Re: Application for Comprehensive Permit – 8 Delanson Circle, Wellesley

As you may recall, this firm represents neighbors and abutters to the proposed 90-unit apartment building on 1.42 acres of land located at 1-8 Delanson Circle, Wellesley (the “Project” and the “Project Site”), which is the subject of a pending application for a comprehensive permit under General Laws Chapter 40B, Sections 20-23 proposed by Delanson Realty Partners, LLC (the “Developer”). The purpose of this letter is to put on record the Neighbors’ continuing concerns with the proposed Project and suggestions for the Board moving forward.

LANDSCAPE PLAN

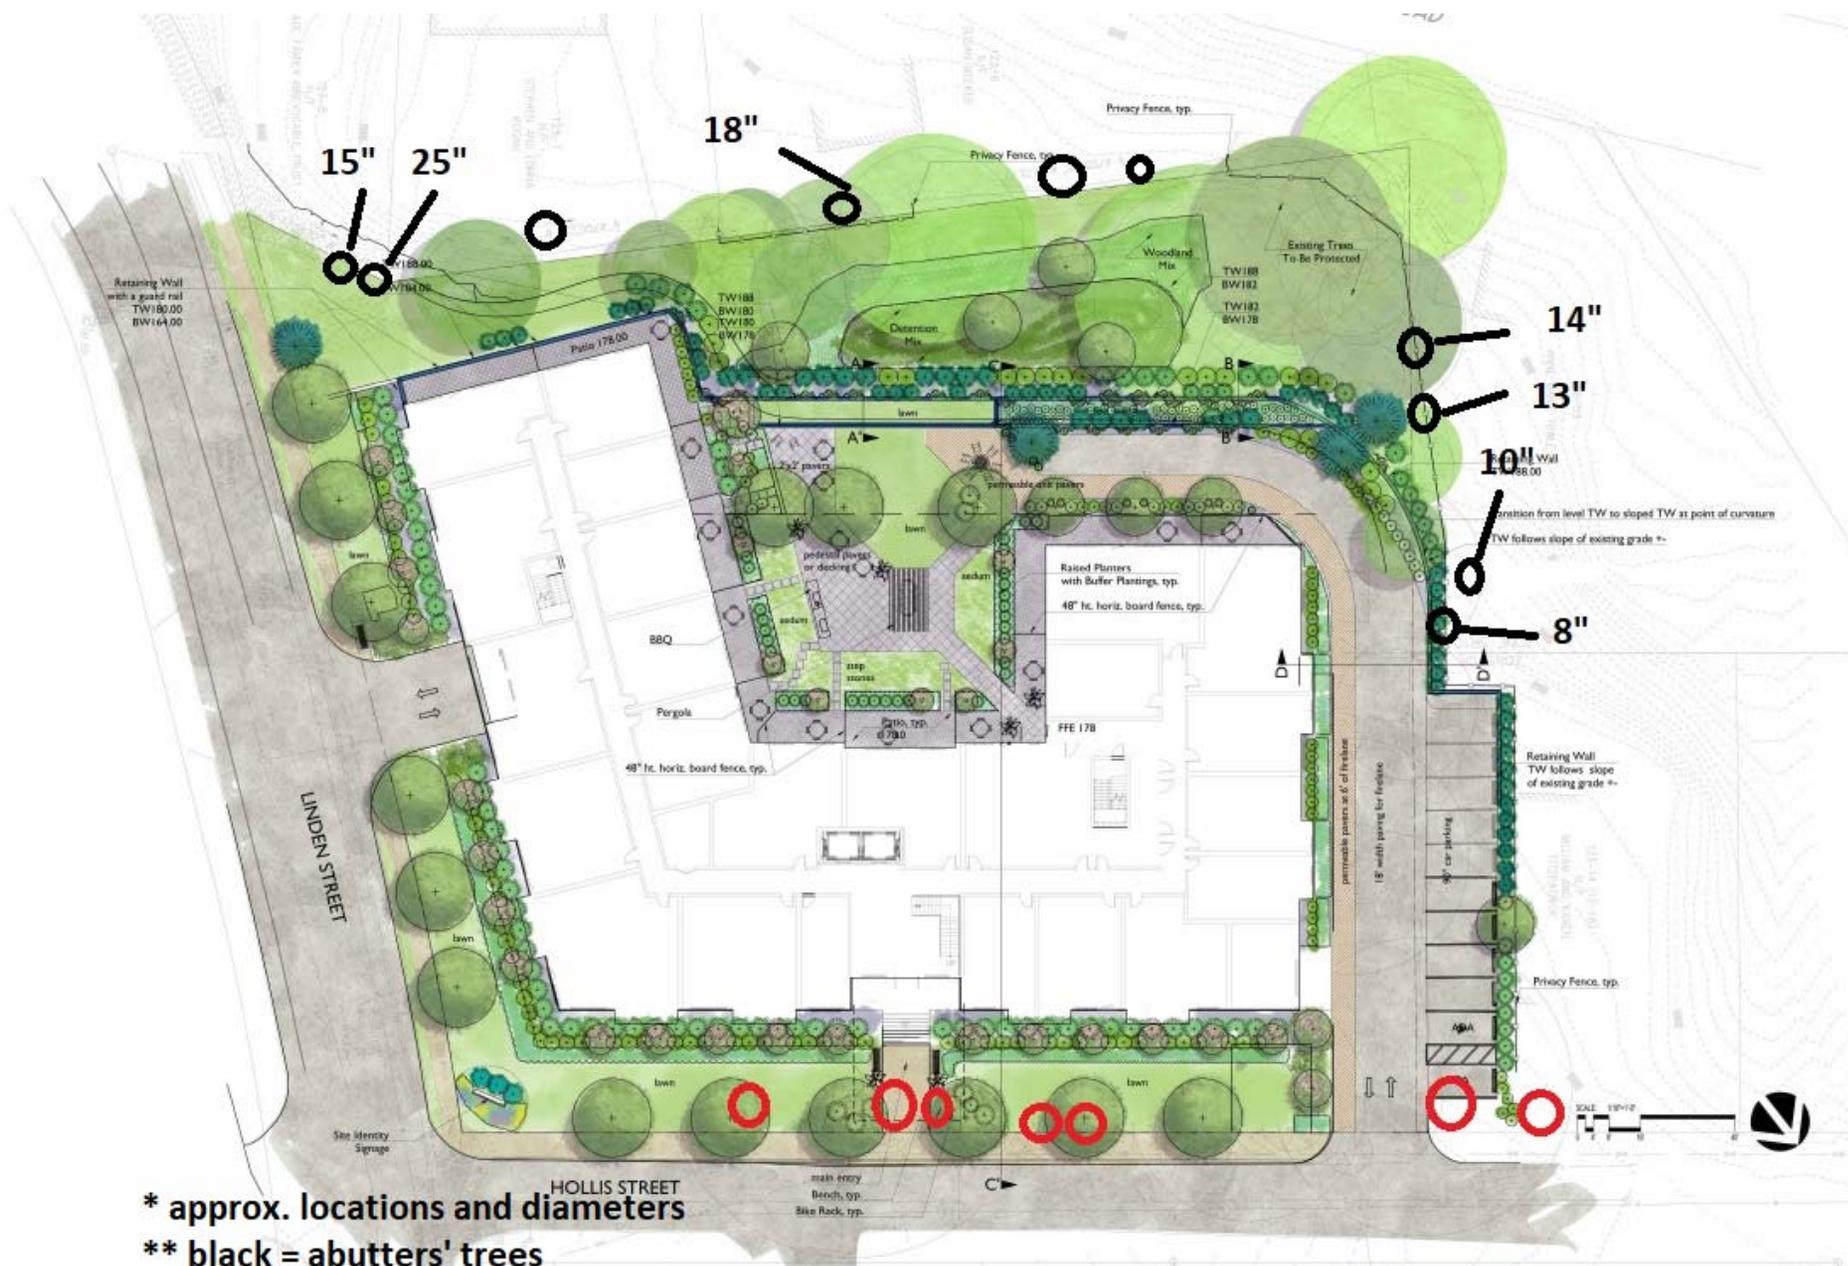
The Neighbors have identified over two dozen trees all of which would trigger the protections afforded under this Bylaw. Admittedly, none of the Neighbors are arborists, and it was difficult to identify whether many of these trees were on the Project Site or abutting properties (the boundary lines have not been staked out). The Town's Tree Bylaw should also be interpreted to require a developer to address the protection of trees on *abutting* properties within close proximity to property line, which the Developer does not have the option of removing. Concern for these trees is particularly justified given the current steep grade changes and presence of ledge throughout the Project Site. Abutter trees along the Project Site's property lines are at risk of destabilization from the demolition of the five buildings that currently occupy the Project Site. A sketch showing the approximate location and size of the abutters' trees is attached as Exhibit A.

The Developer's vague note on a corner of the Landscape Plan that "Existing Trees To Be Protected" is meaningless. The Developer has not clearly identified or located the existing Site trees on its plans. This preliminary work must be done to ensure that all of these trees (including abutters' trees) are properly protected through a Tree Retention Plan, and that any Site trees to be removed are replaced in kind, or otherwise the appropriate donation to made to the Tree Bank.

The Developer should further submit a tree survey identifying all trees within 10 feet of the side and rear property lines and 20 feet of the front property line(s) as well as tree species, DBH, maturity, and critical root zone. For all trees to be retained, as well as trees on abutting properties, Developer should submit a Tree Retention Plan prepared by a Certified Arborist. The Developer should be required to submit a plan for replacing removed trees, and if 100% replacement cannot be achieved, Developer should contribute to the Tree Bank in accordance with this Bylaw.
